**Monitoring Year 1 FINAL Monitoring Report**  
**Stewarts Creek Tributaries Stream Restoration Project**  
**Surry County, North Carolina**  
**Yadkin River Basin, Hydrologic Unit Code (HUC) 03040101**

**RE: Response to Draft MY1 Monitoring Report (MY0) Comments dated December 4, 2020  
Stewarts Creek Stream Restoration Project  
Yadkin River Basin – CU# 03040101 – Surry County, North Carolina  
NCDMS Project # 100023, Contract # 7183**

**RE: Response to IRT Comments dated November 6, 2020  
Stewarts Creek Stream Restoration Project  
Yadkin River Basin – CU# 03040101 – Surry County, North Carolina  
NCDMS Project # 100023, Contract # 7183**

**STEWARTS CREEK TRIBUTARIES**  
**STREAM RESTORATION PROJECT**  
 CURRENT CONDITION PLAN VIEW: ASSET MAP  
 MY1: 2020

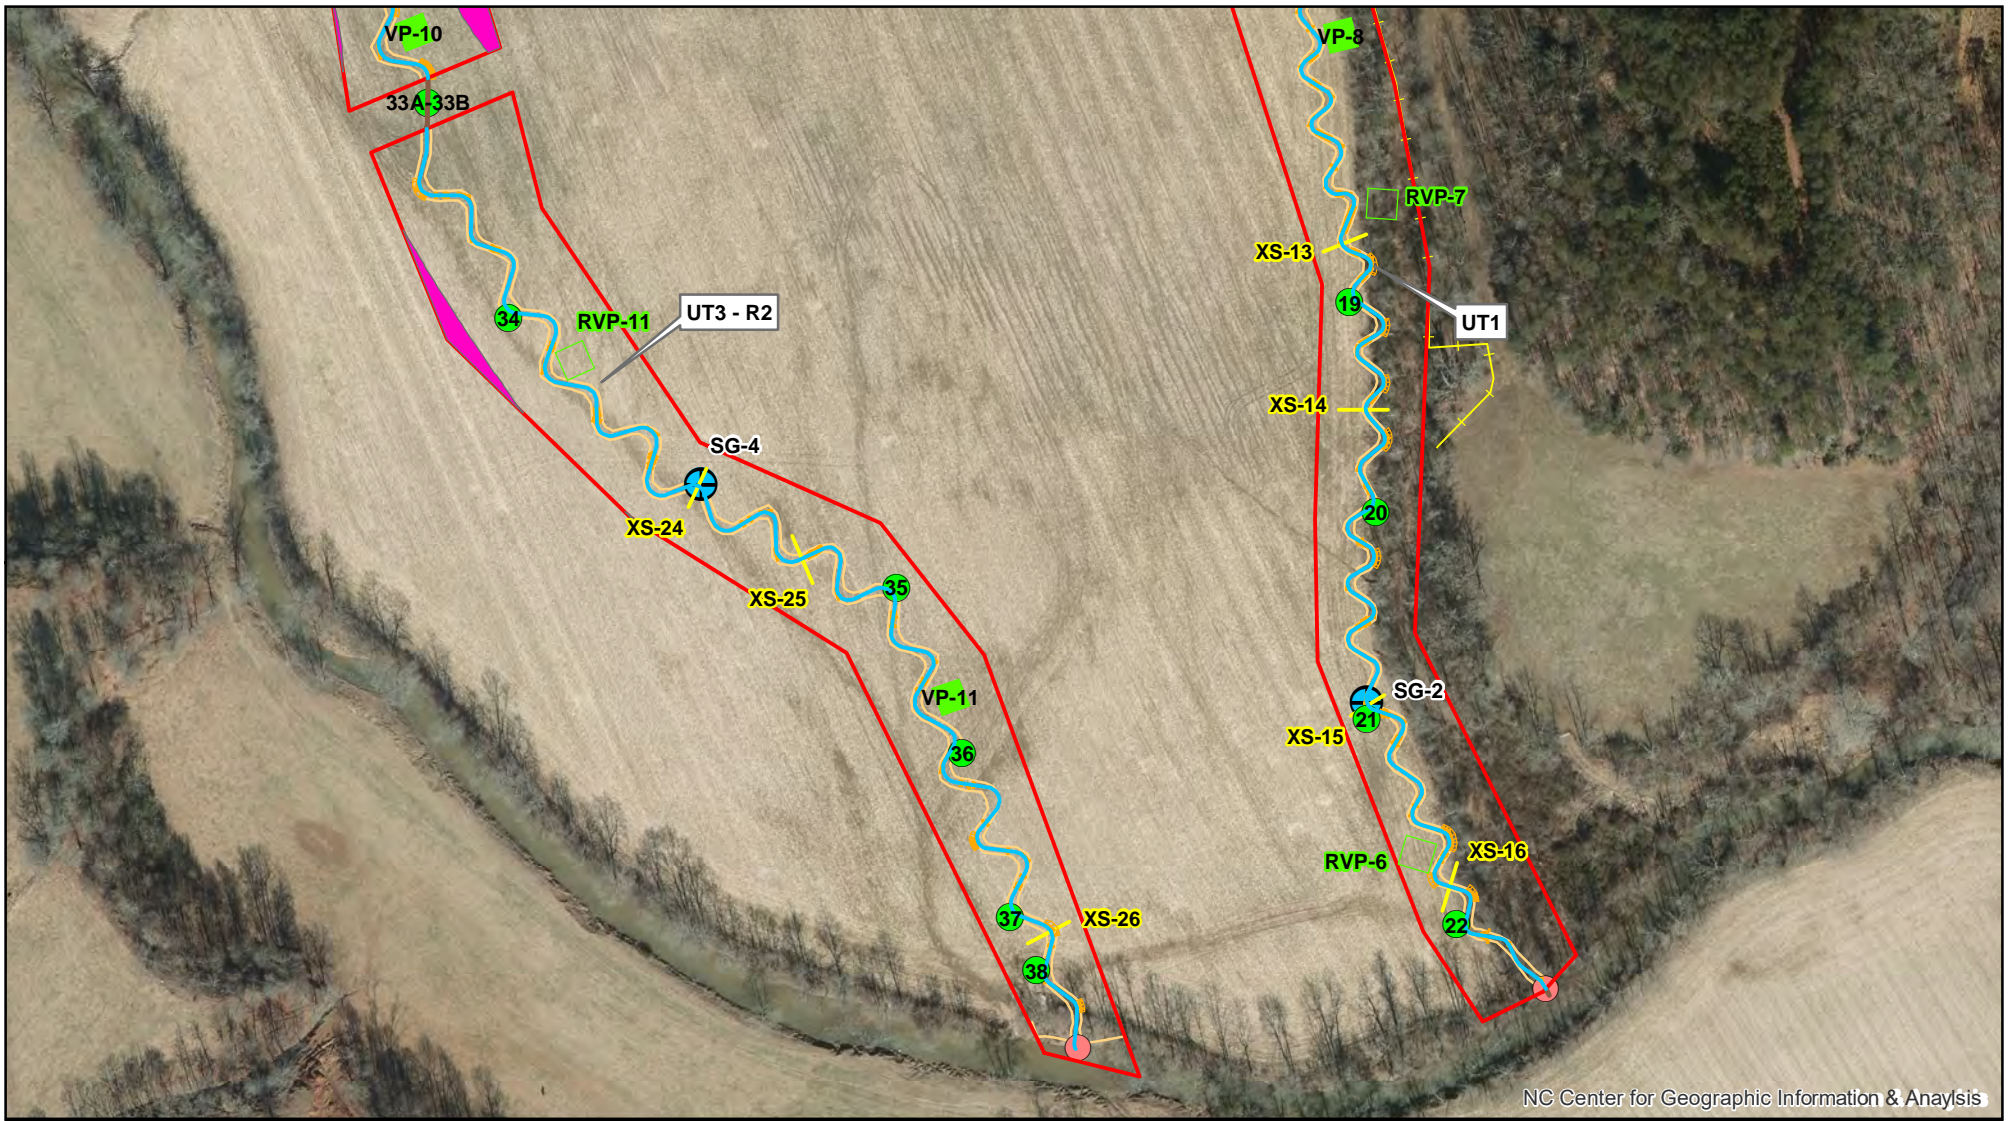
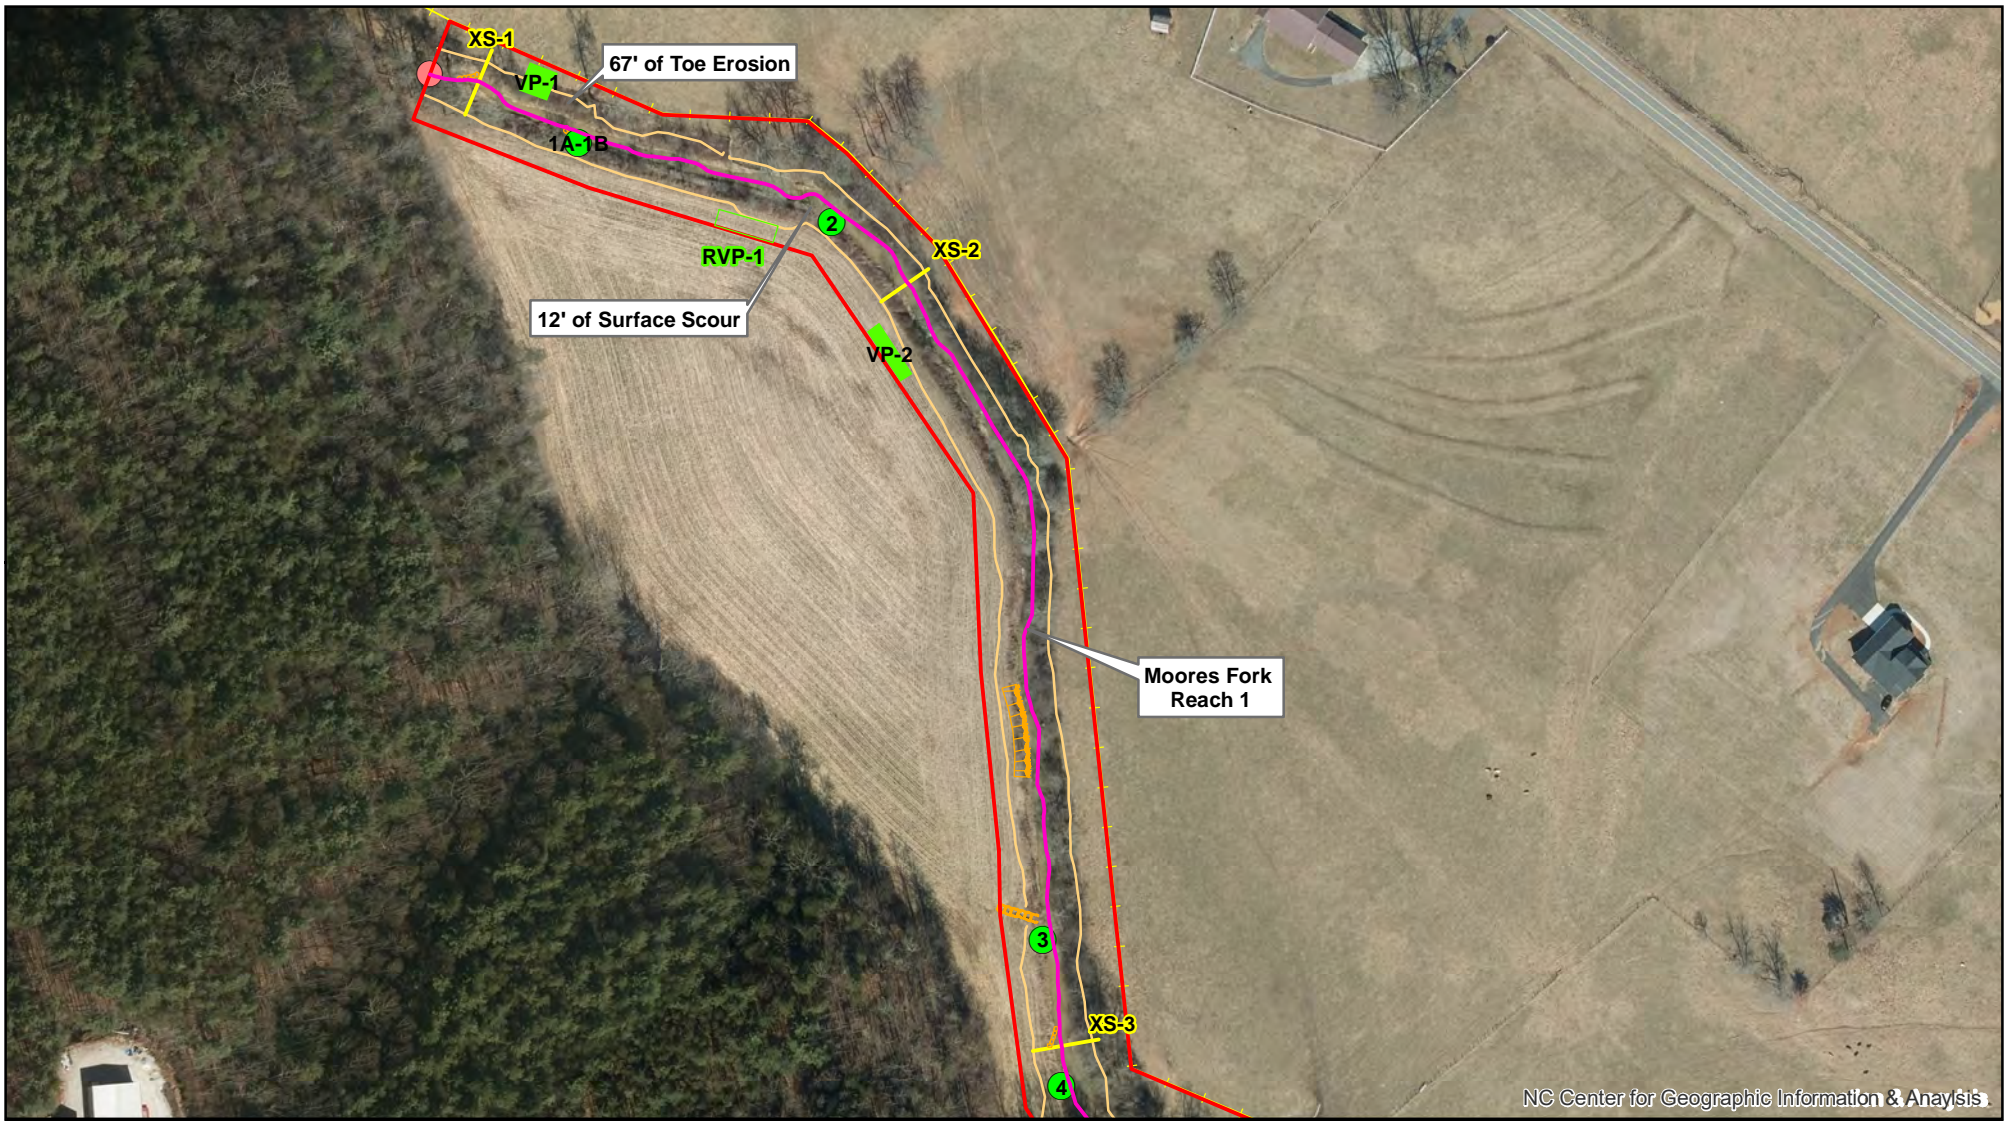
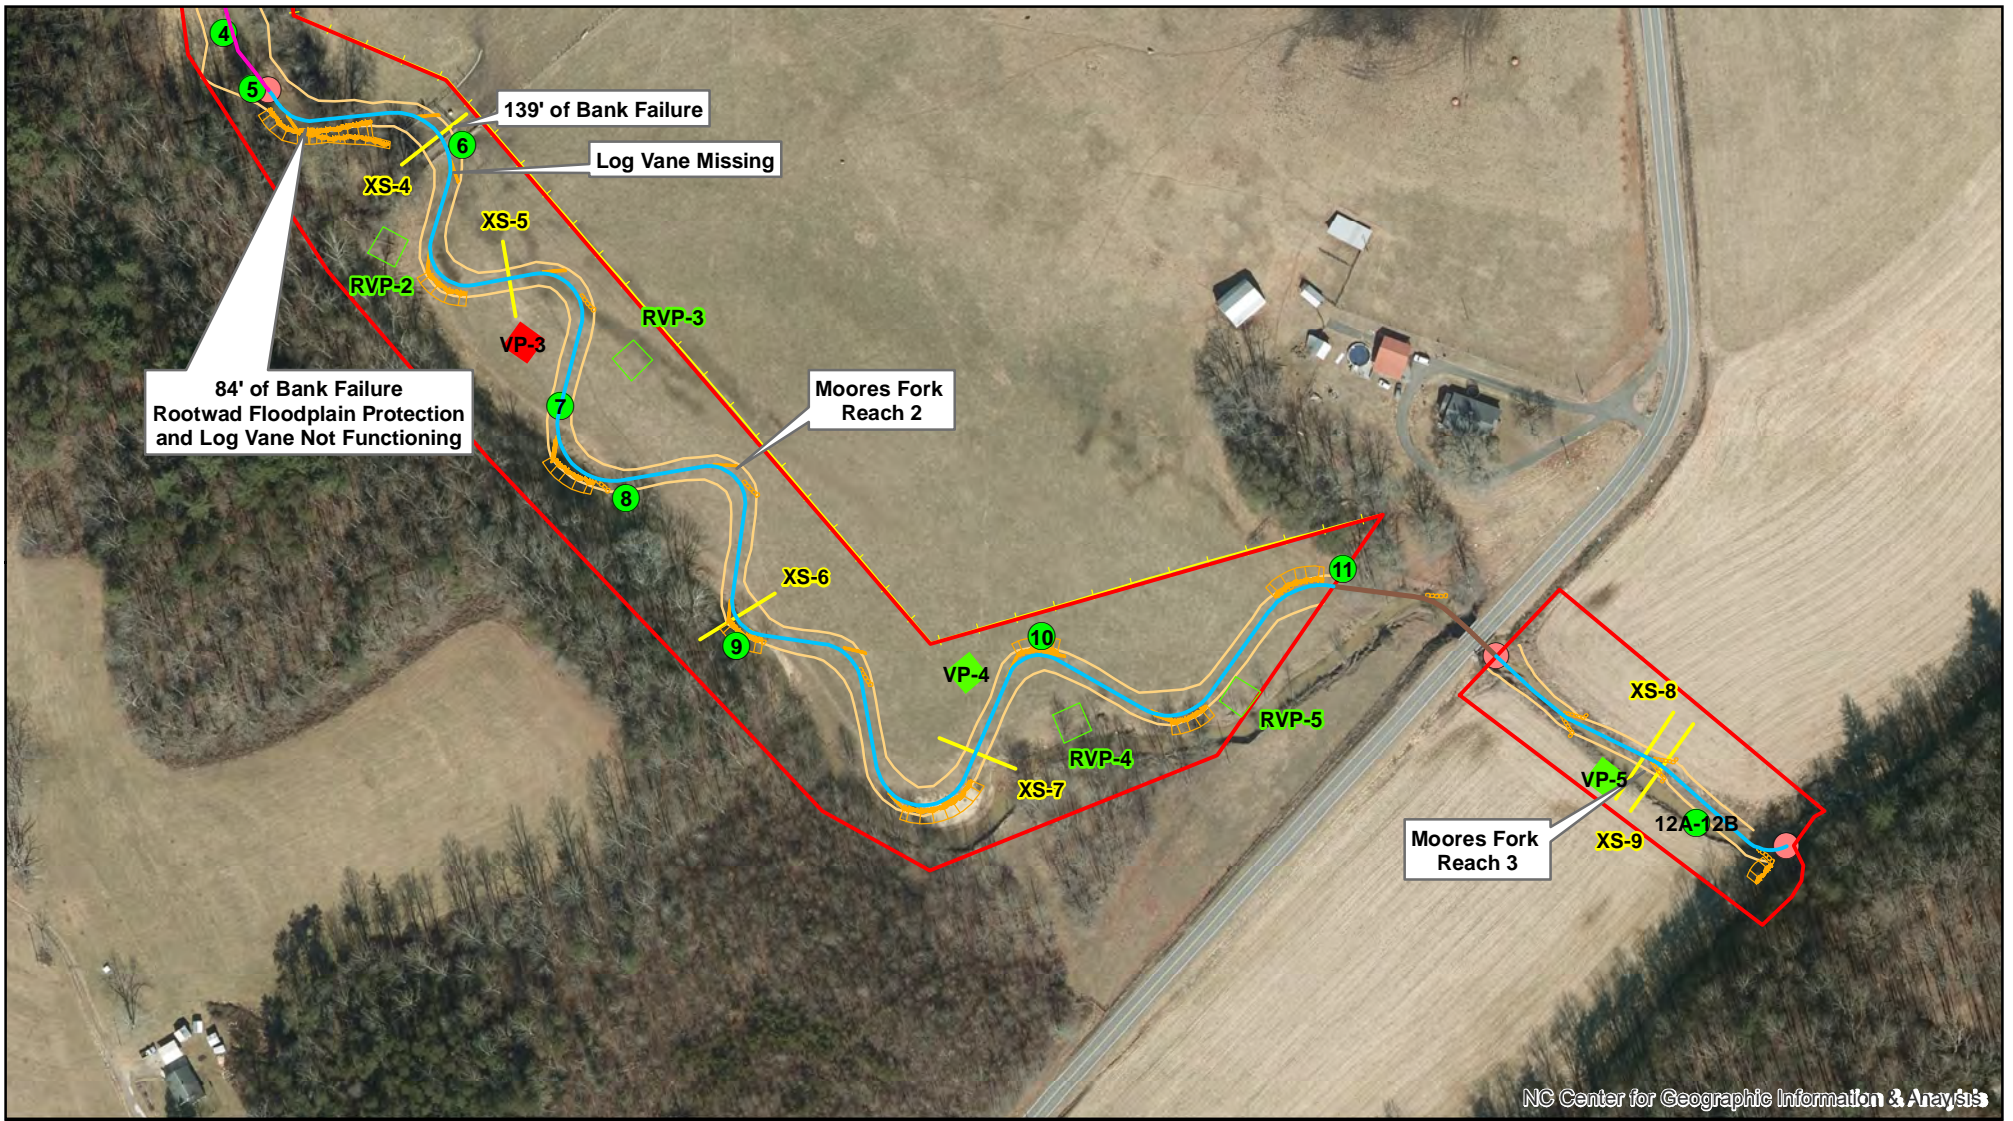
- *CCPV Maps: The MY3 interim success criteria for the project is 320 stems/acre. Please show any vegetation plots that do not meet the interim success criteria as “red” on the CCPV Maps.*
  - **Updated.**

### SCTSG4

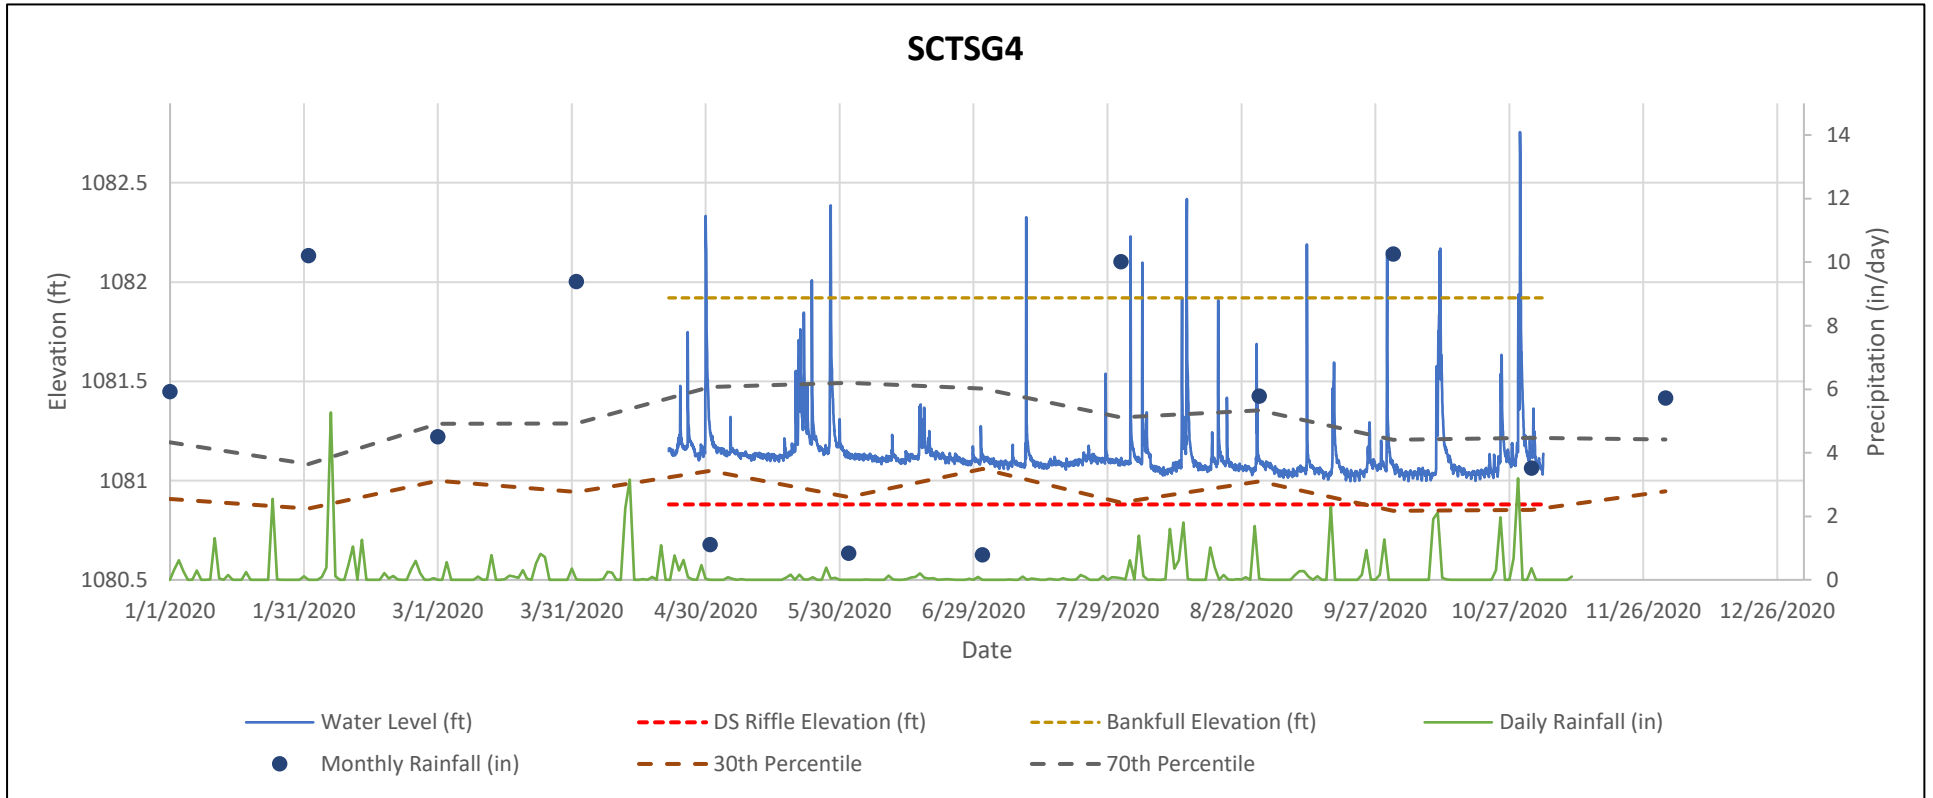
- *Section 2.1.4 Stream Hydrology: In the report text, please review and provide additional discussion regarding the numerous bankfull events reported. Does EPR have any concerns with 11 bankfull events reported on UT3 Reach 2 (gauge SG-4)?*
  - **These numerous bankfull events on UT3 Reach 2 are likely influenced by the low top of bank depths allowing flood flows to easily access the floodplain in addition to the excessively wet year. This reach is performing as intended and show no signs of instability; therefore, the number of bankfull events is not concerning.**
